# Access Compliance Report

## Public Rights-of-Way

### (Curb Ramps)

Intersection ID: 10027508	Main Street: GRANDIFLORA_DR	Cross Street: N/A	Location: SE
ADA ID: B263CEB4A22E	Ramp Type: PerpDiag	Initial Pass/Fail: Fail	Overall Compliance: No
Codes/Mitigation Info/Possible Solution		Field Measurements/Component Compliance	
Severity Score: 8.75

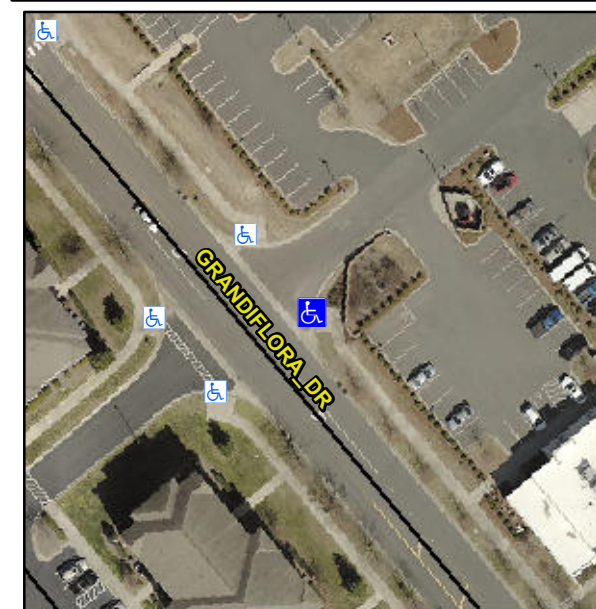
**Not Found, R304.5.1**

Compliance	Description	Data	Compliance	Description	Data
N/A	Ramp Length (in)	97.0	Yes	Ramp Slope (%)	7.7
No	Ramp Width (in)	45.0	Yes	Ramp XSlope (%)	0.6
N/A	Flare Type LT	N/A	N/A	Flare Type RT	N/A
N/A	Flare Slope LT (%)	N/A	N/A	Flare Slope RT (%)	N/A
N/A	Flare Traversable LT?	N/A	N/A	Flare Traversable RT?	N/A
N/A	Landing Length (in)	N/A	N/A	DWS Provided?	N/A
N/A	Landing Width (in)	N/A	N/A	DWS Contrast?	N/A
N/A	Landing Slope (%)	N/A	N/A	DWS Length (in)	N/A
N/A	Landing X Slope (%)	N/A	N/A	DWS Full Width?	N/A
N/A	Landing Curb? (Y/N)	N/A	N/A	DWS Offset (in)	N/A
N/A	Shared Landing?	N/A			
N/A	Gutter Ponding?	N/A	N/A	Gutter Slope (%)	N/A
N/A	Gutter Lip Ht (in)	N/A	N/A	Gutter X Slope (%)	N/A
N/A	Painted X Walk1?	No	N/A	Painted X Walk2?	No
	X Walk 1 Direction	To NW		X Walk 2 Direction	To SW
N/A	X Walk 1 Width (in)	N/A	N/A	X Walk 2 Width (in)	N/A
	X Walk 1 Slope (%)	0.8		X Walk 2 Slope (%)	1.4
	X Walk 1 X Slope (%)	0.5		X Walk 2 X Slope (%)	1.2

**Remove & Replace Curb Ramp With Two New Directional Ramps or Equivalent.**
